Clarifications and Changes to Chapter 1

Clarifications and Changes to Chapter 2

Figure 2-2. Preferred Restoration Alternative

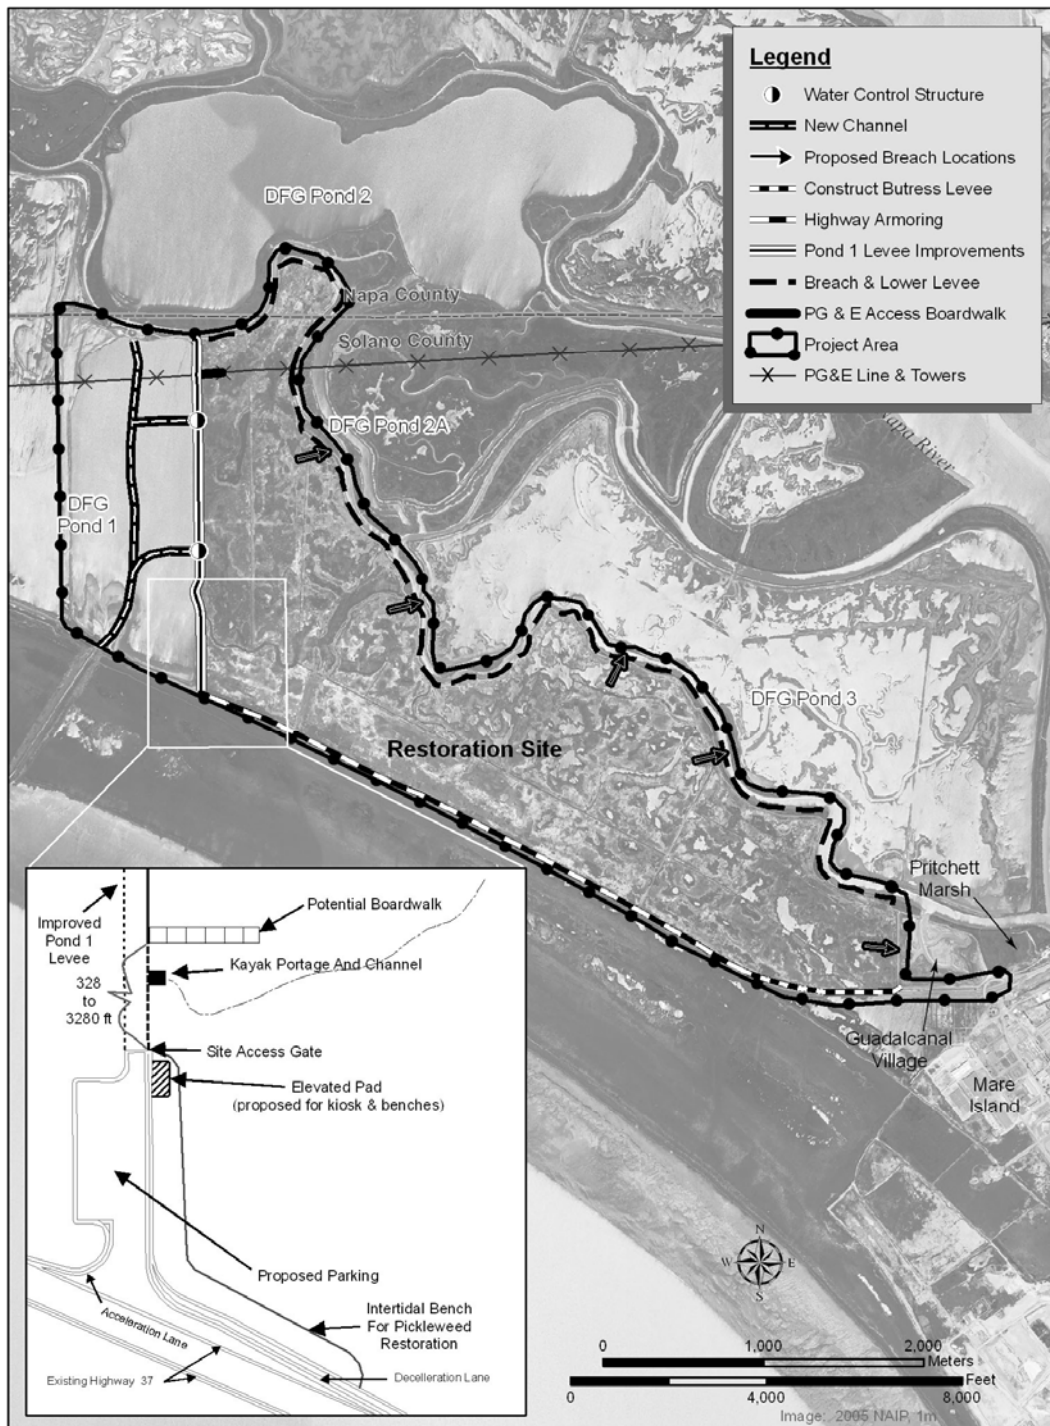
3. Page 39, Figure 2-2 has been revised and the revised figure is below.

Figure 2.6. Proposed Highway 37 Improvements

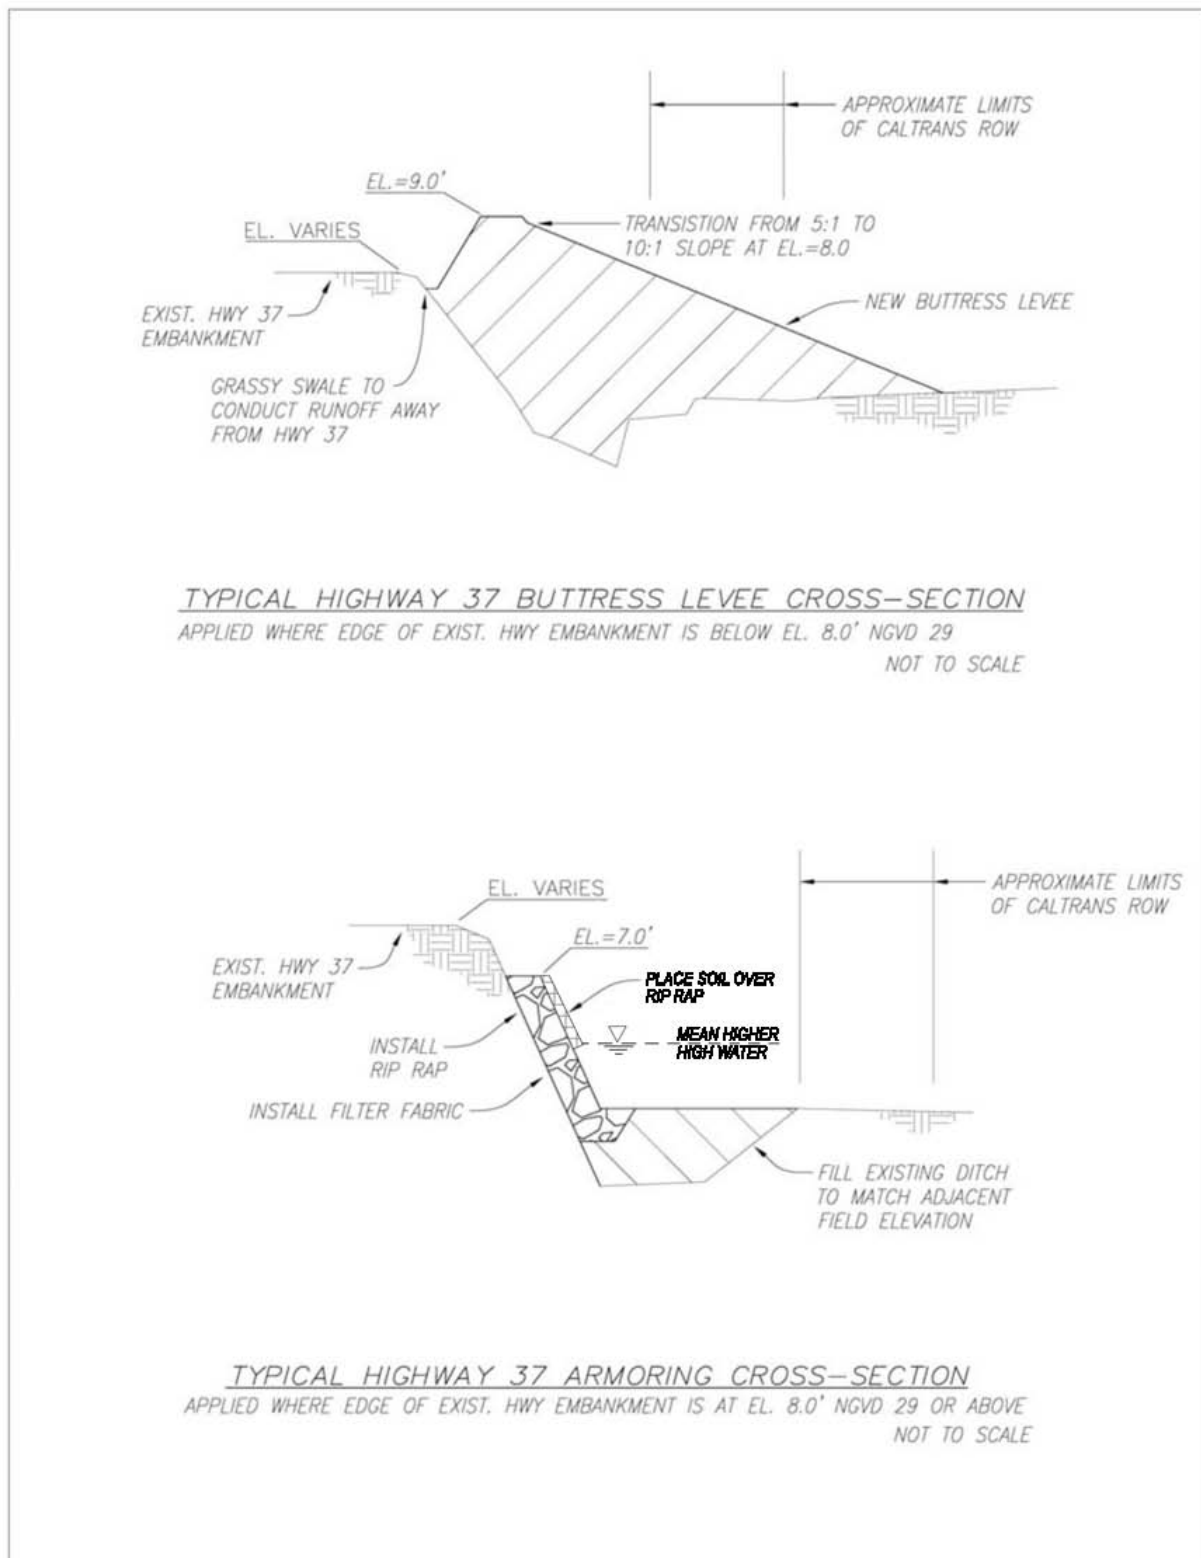
6. Page 47, Figure 2-6 has been revised and the revised figure is below.
